Civic Design Review Re-submission
August 09, 2022

4200 MARKET ST

Mixed-Use | Residential Development

**Re: 4200 Market Street
L&I Application No. ZP-2022-002188
Revised CDR Submission**

SHEET TITLE:
VEHICLE CIRCULATION PLAN

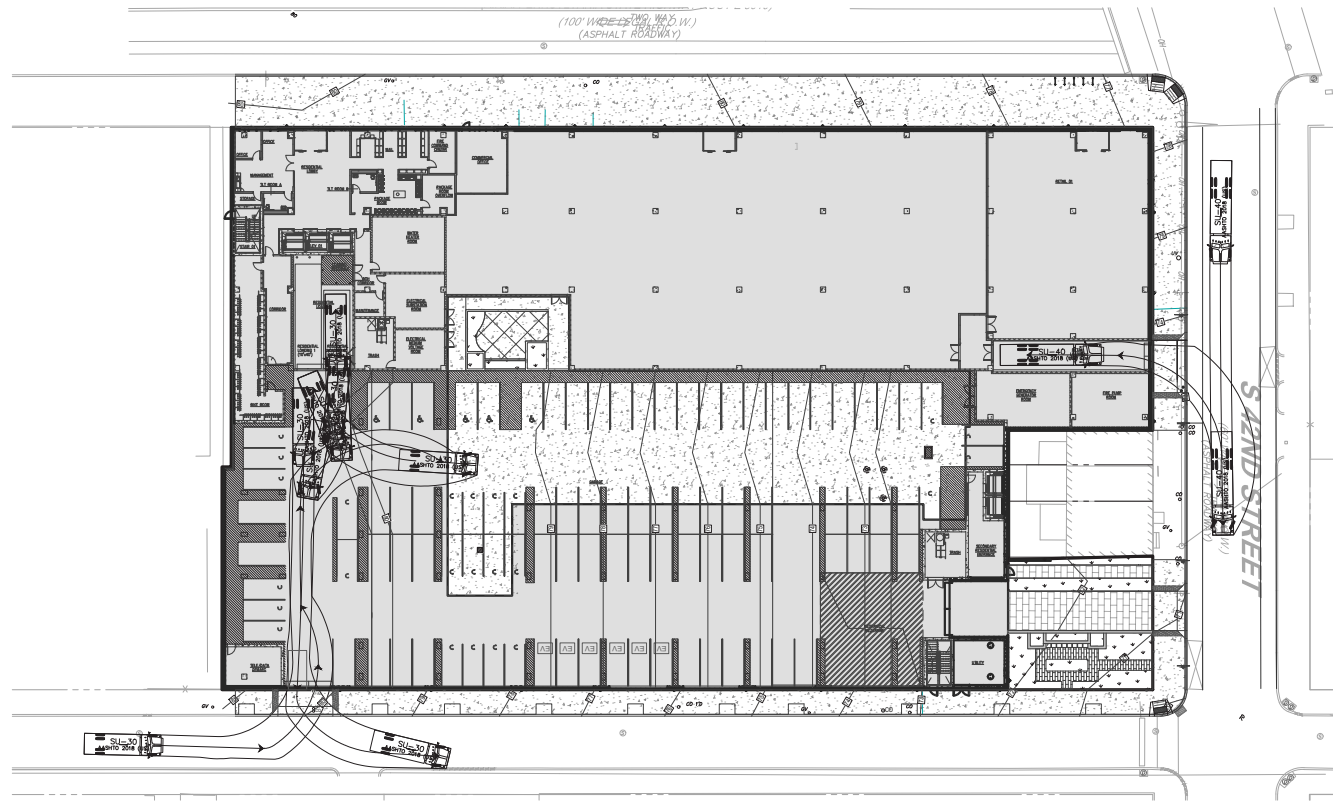
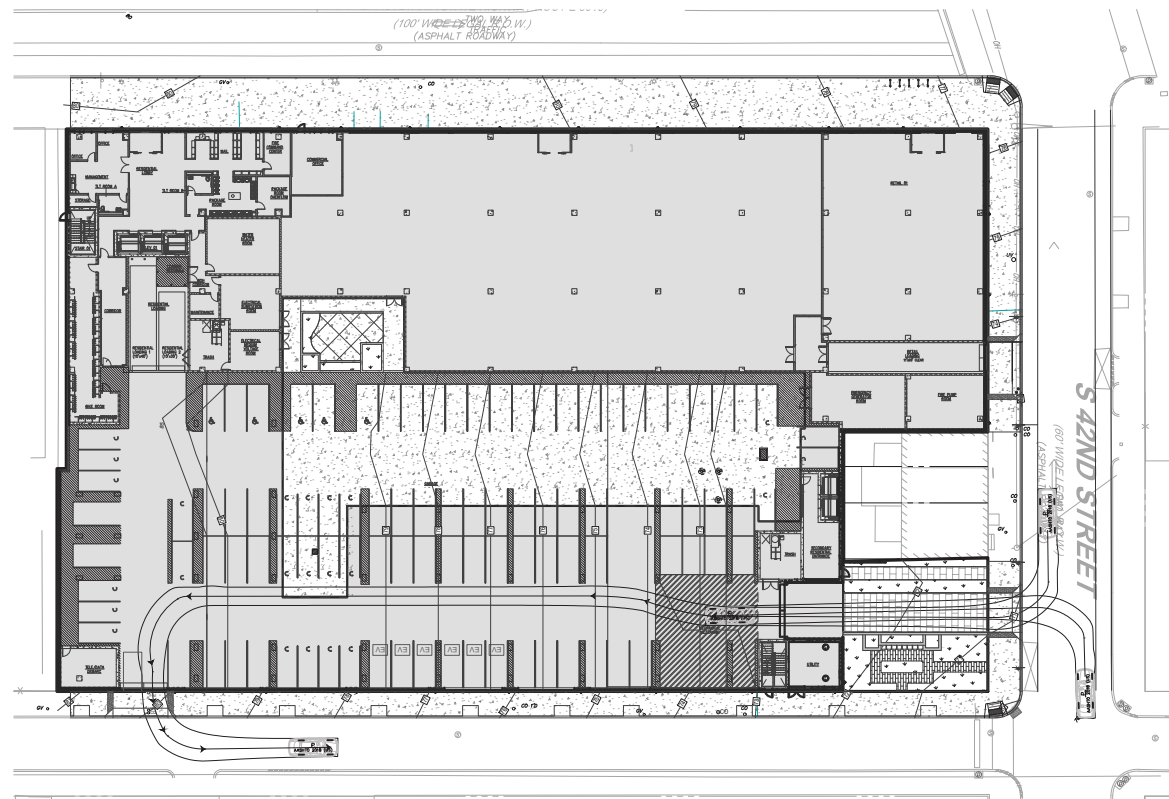
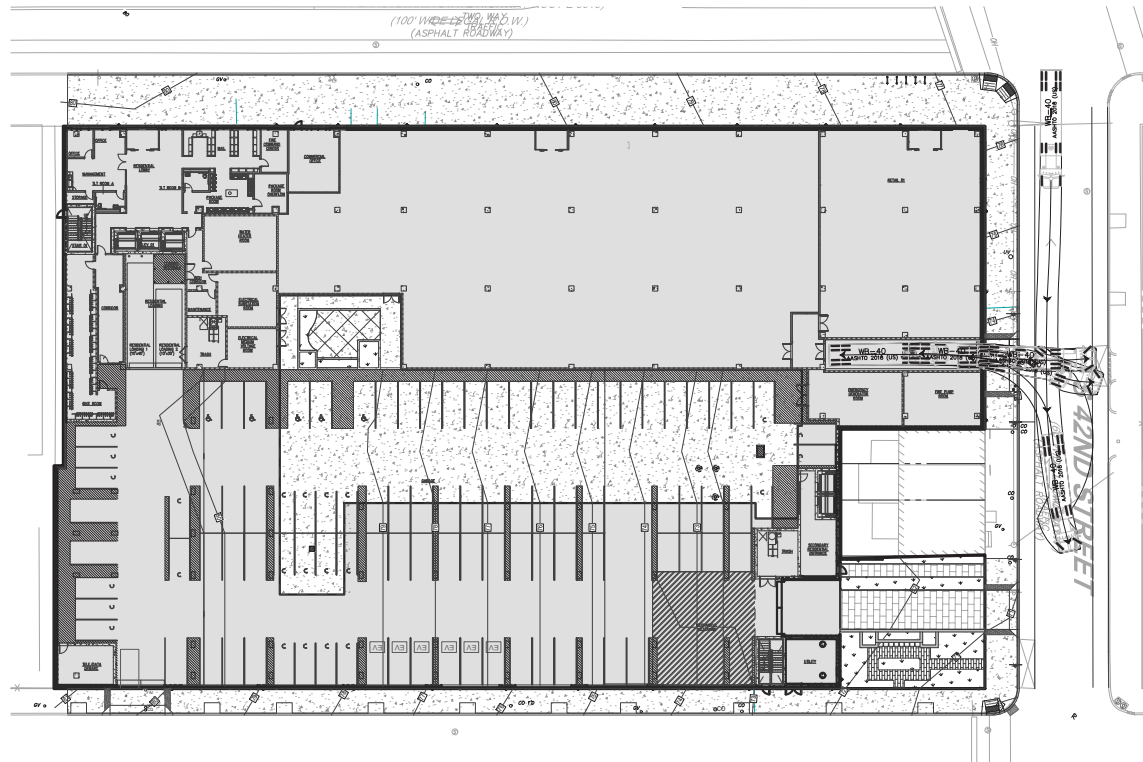
Alterra appreciates all the feedback and comments that have been provided by the community to date. Specifically, Alterra is sensitive to the need to mitigate potential traffic conflict between the retail loading proposed and the adjacent school along 42nd Street. Retail loading will be managed through planned delivery schedules so as to minimize impacts to peak traffic levels and the school operation. Alterra has also agreed to enter into a Community Benefits Agreement with West Powelton in connection with this Project and will continue to engage with the wider community as the development process proceeds.

In addition to improving to the aesthetic experience at this corner, the enhanced landscaping program will serve to separate pedestrian spaces from driving spaces. The parking entrance near Ludlow Street on 42nd Street has also been reduced to a single lane one-way in to reduce conflicts with the public realm while enhancing the end user experience. Revised landscaping and site plans showing the changes proposed to the design of this corner are included within the revised Application materials submitted for your review.

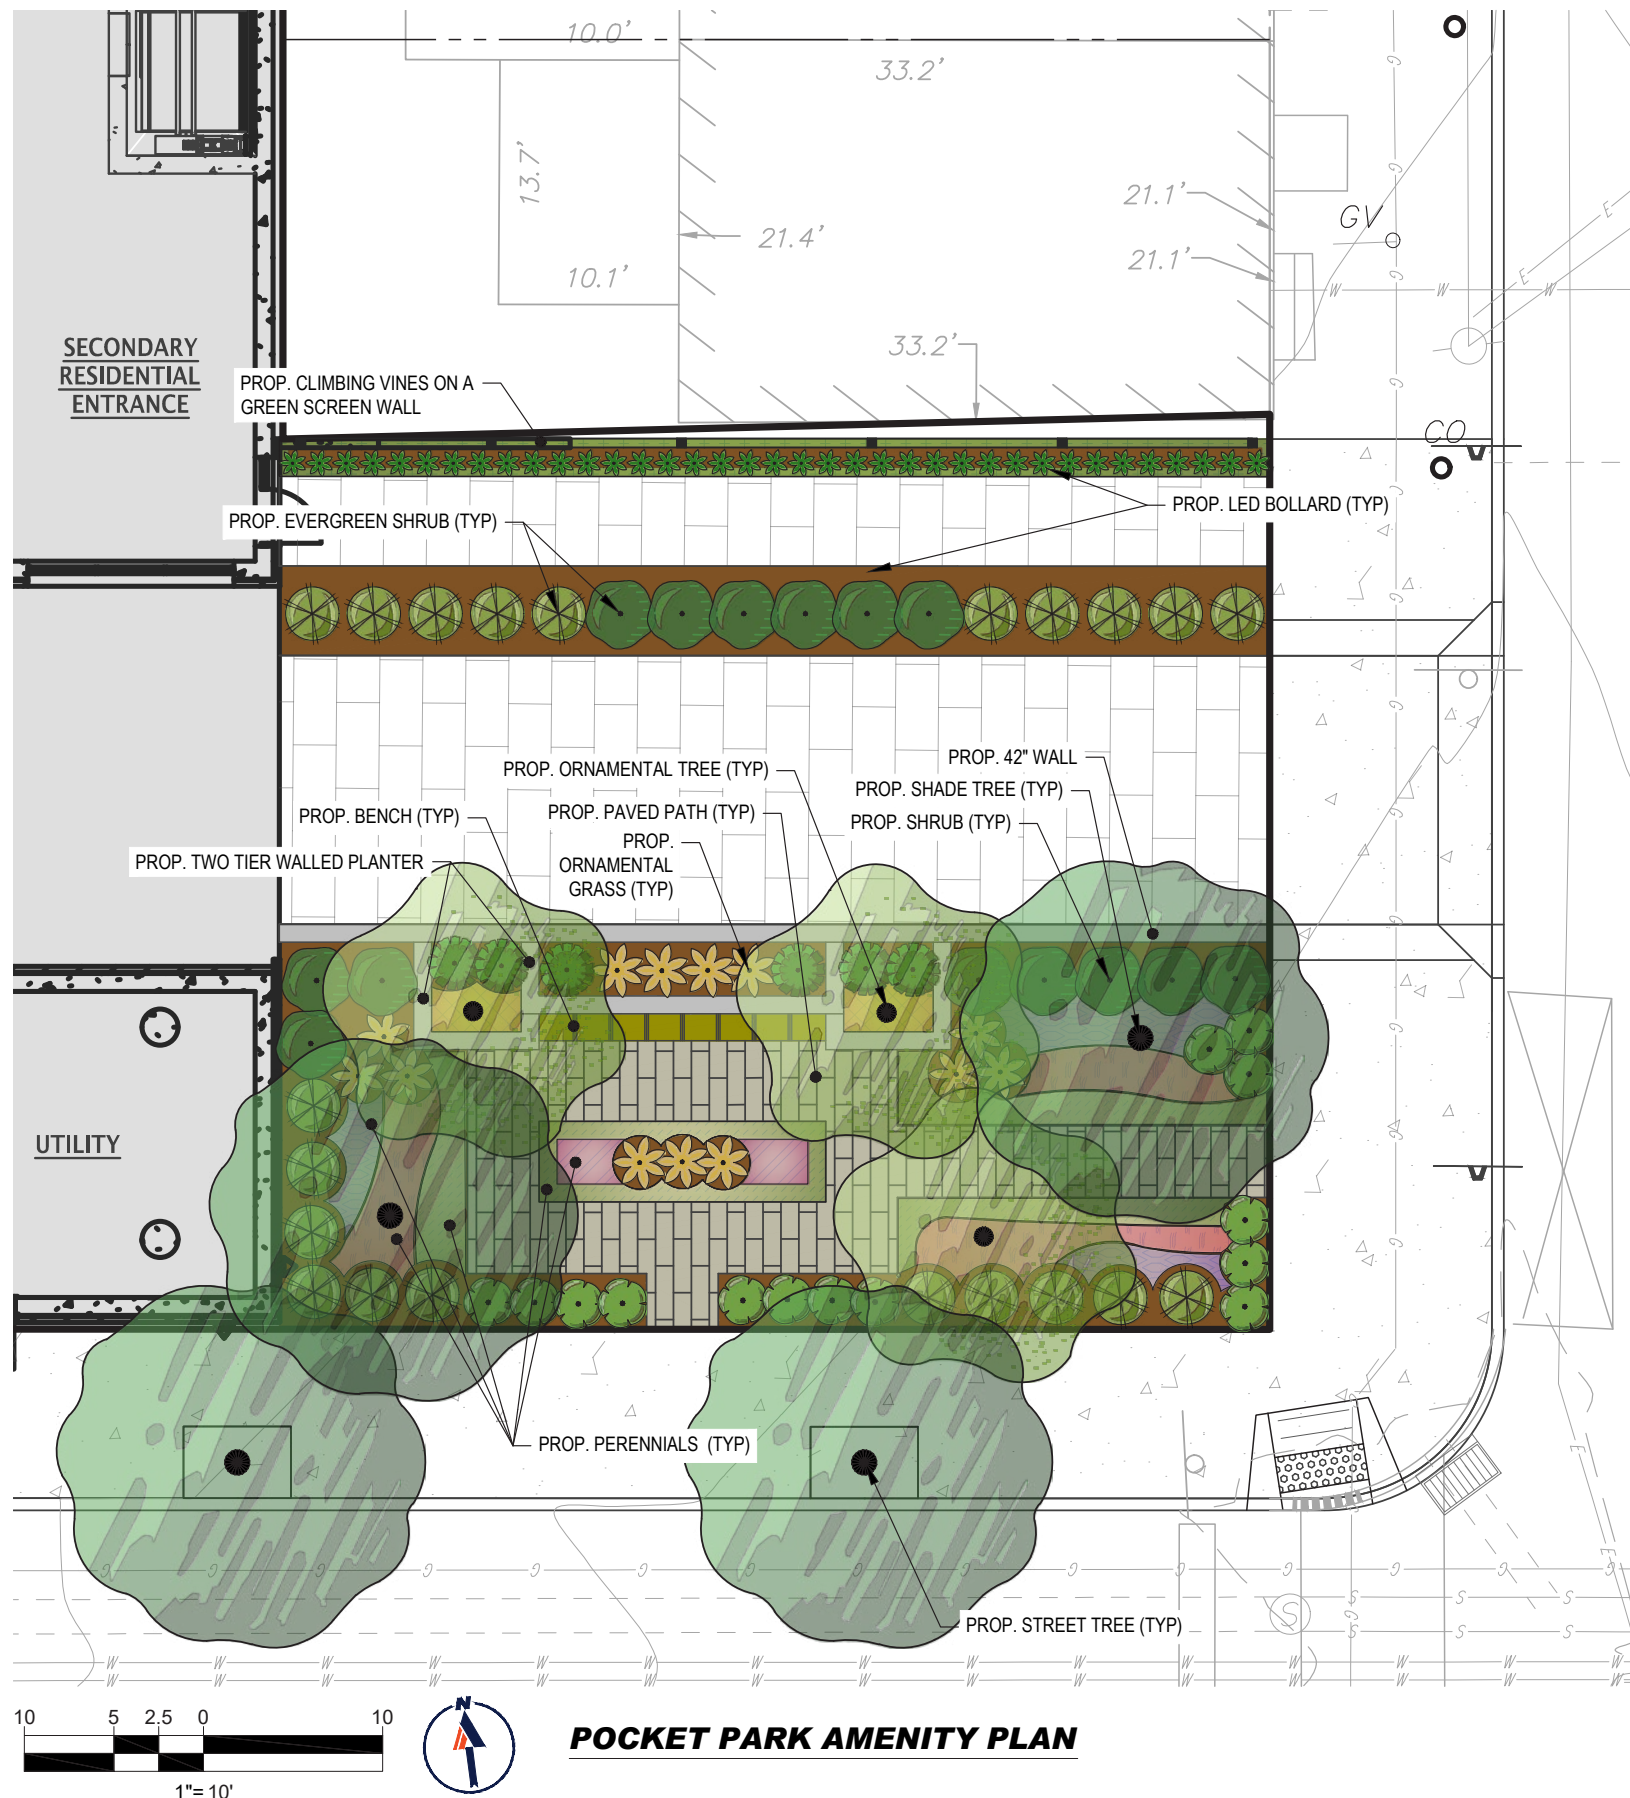
The pocket park and the secondary pedestrian access along 42nd Street have also been enhanced. In addition to the landscaping and traffic design changes discussed above, a trellis-supported green wall is now proposed adjacent to the three row homes located along 42nd Street, which accentuates the pedestrian approach to the secondary lobby. Revised plans showing the proposed changes are included within the revised Application materials submitted for your review.

As discussed above, the improvements also include an enhanced design of the proposed pocket park and vehicle circulation at the 42nd Street parking entrance. The design of the park has progressed to include trees, multiple planting beds, distinct seating areas and hardscapes walkways. The space will not be gated or fenced as it is intended for public use. Dark-Sky-compliant site lighting will also be provided with the park to create a well-lit space at night. The park materials, vehicular driveway and pedestrian walkway are all distinct and will be separated by plantings and architectural elements. The parking garage driveway has been redesigned as ingress only to remove the awkward interaction caused by vehicles leaving the garage and driving close to the park. A 42” brick site wall will provide further separation between the park and drive aisle. In addition, the pedestrian walkway will be flanked by plantings and the previously mentioned green wall.
